**DECISION OF THE PLANNING ADMINISTRATOR**

**PARTITION TENTATIVE PLAN CASE NO.: PAR24-07**

**APPLICATION NO.: 23-120089-PLN**

**REQUEST:** An application for a Partition Tentative Plan to divide an approximate 1.96-acre property into two parcels approximately 65,810 square feet and 19,464 square feet in size. The subject property is zoned RS (Single Family Residential), approximately 1.96 acres in size, and located at 6450 Lone Oak Road SE (Marion County Assessor’s Map and Tax Lot Number: 083W22BC02200).

Attachment B

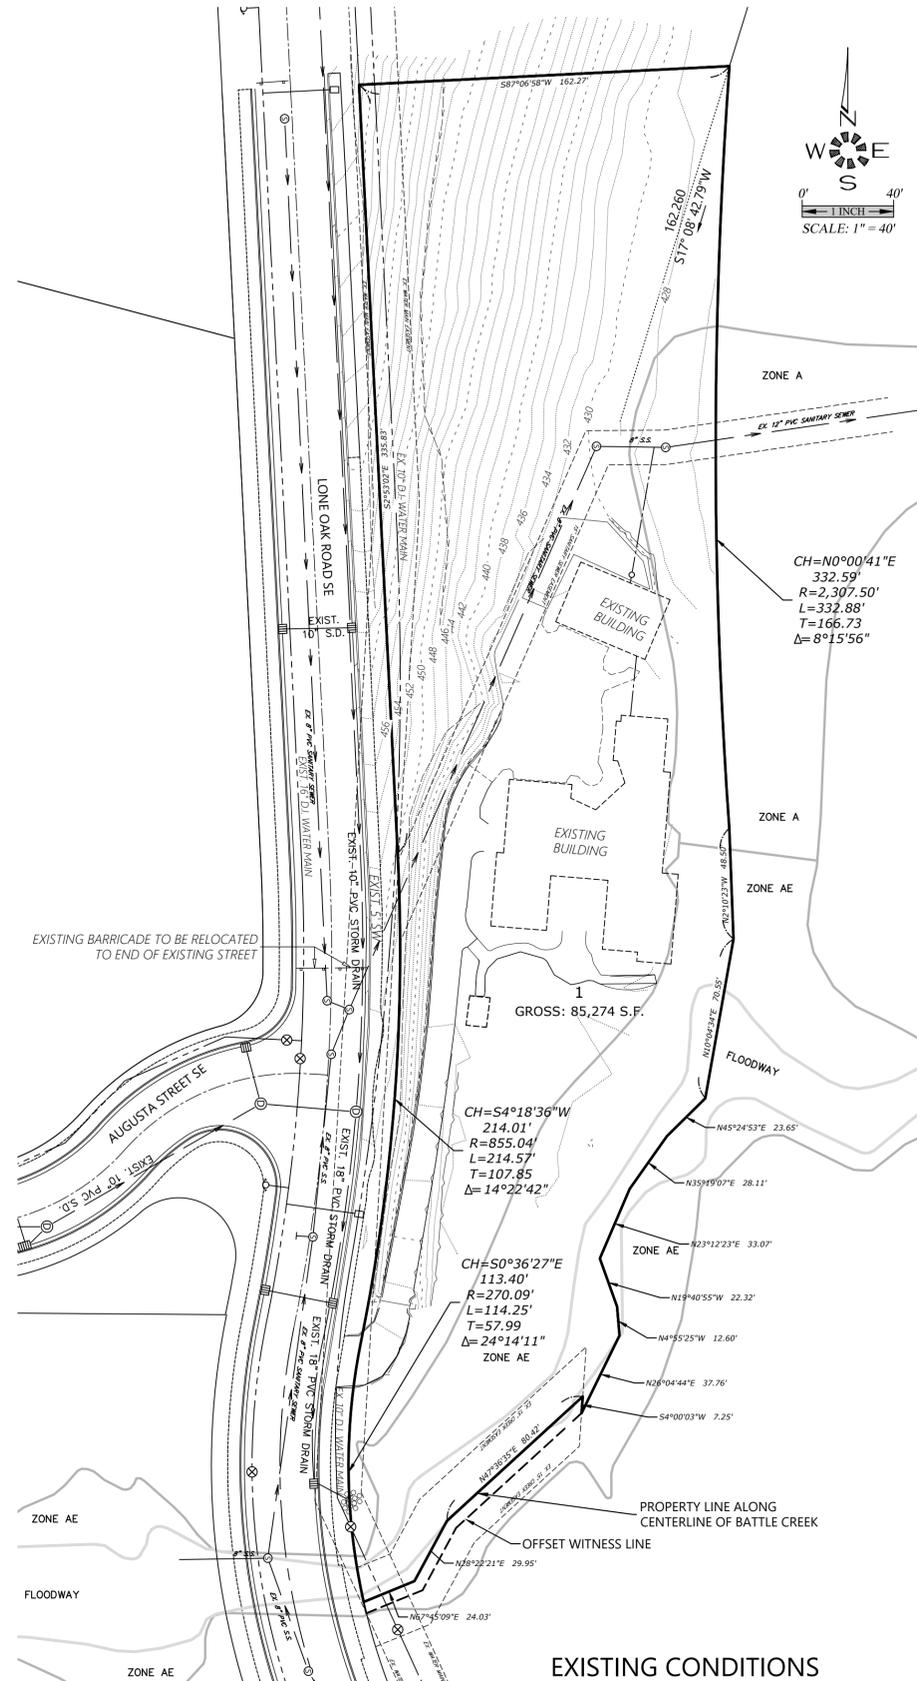
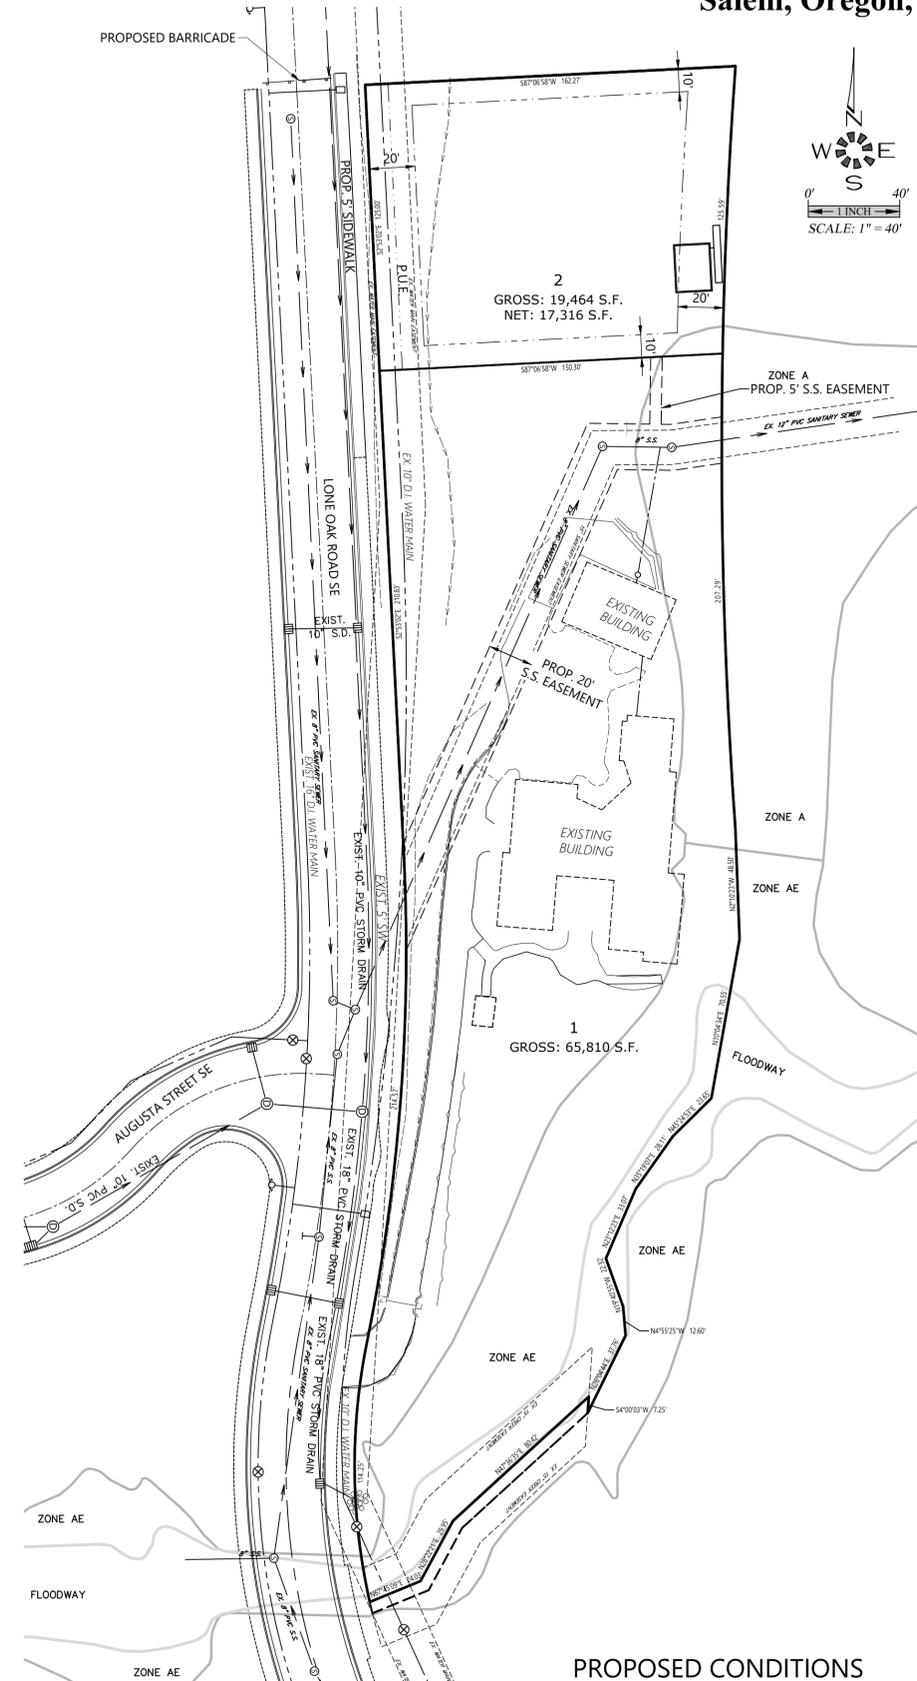
As shown on the tentative partition plan (**Attachment B**), the proposed partition divides the subject property into two parcels. Proposed Parcel 1 is approximately 65,810 square feet in size and proposed Parcel 2 is approximately 19,464 square feet in size. Both proposed parcels exceed the minimum required lot size, dimension, and street frontage requirements of the RS zone.

As measured on the tentative partition plan, the existing detached single-family dwelling and accessory buildings on proposed Parcel 1 exceed the minimum required setbacks of the RS zone. Any future development on this parcel, and any future development on proposed Parcel 2, will be reviewed for conformance with applicable setback requirements at the time of future building permit and/or site plan review. The proposed development conforms to the setback requirements of the RS zone.

Within the RS zone, the maximum lot coverage requirement for buildings and accessory structures is 60 percent. As measured on the tentative partition plan, the existing detached single-family dwelling and accessory buildings on proposed Parcel 1 do exceed the maximum allowed lot coverage of the RS zone. Any future development on this parcel, and any future development on proposed Parcel 2, will be reviewed for conformance with maximum lot coverage requirements at the time of future building permit and/or site plan review. The proposed development conforms to the maximum lot coverage requirements of the RS zone.

The proposed partition includes the creation of two parcels (Parcel 1 and Parcel 2). Both of these lots are considered interior lots with one property line abutting a street. Pursuant to SRC 800.020(a)(1), the front lot line for an interior lot shall be the property line abutting the street. As such, the front lot line for proposed Parcels 1 and 2 shall be the west property line abutting Lone Oak Road SE.

Street SE to the northern property boundary as shown on the applicant's plans.
